## **ADDENDUM NO. 2**

### **MAIN AND PIKE STREET RECONSTRUCTION**

Laura, Ohio

AUGUST 18, 2009

**TYPICAL DRIVE DETAIL**

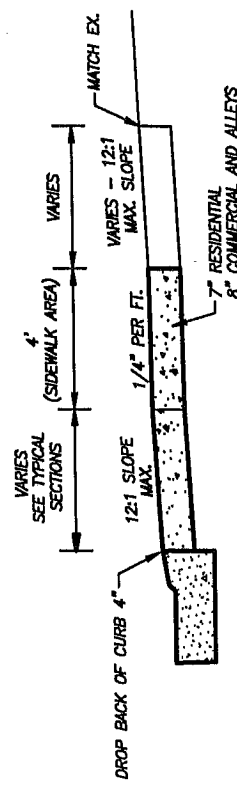
1. A 'Typical Drive Detail' and 'Concrete Sidewalk Detail' were omitted from the plans. There is an attachment for each detail included with this addendum. Please note that the contractor shall be responsible for the preparation of an adequate compacted base for the drive approaches and sidewalk. Typically, an average of 4"-6" of item 304 aggregate base will be needed to provide an adequate base. All costs associated with the completion of a compacted aggregate base for items 452 and 608 shall be included with the bid for each respective item.
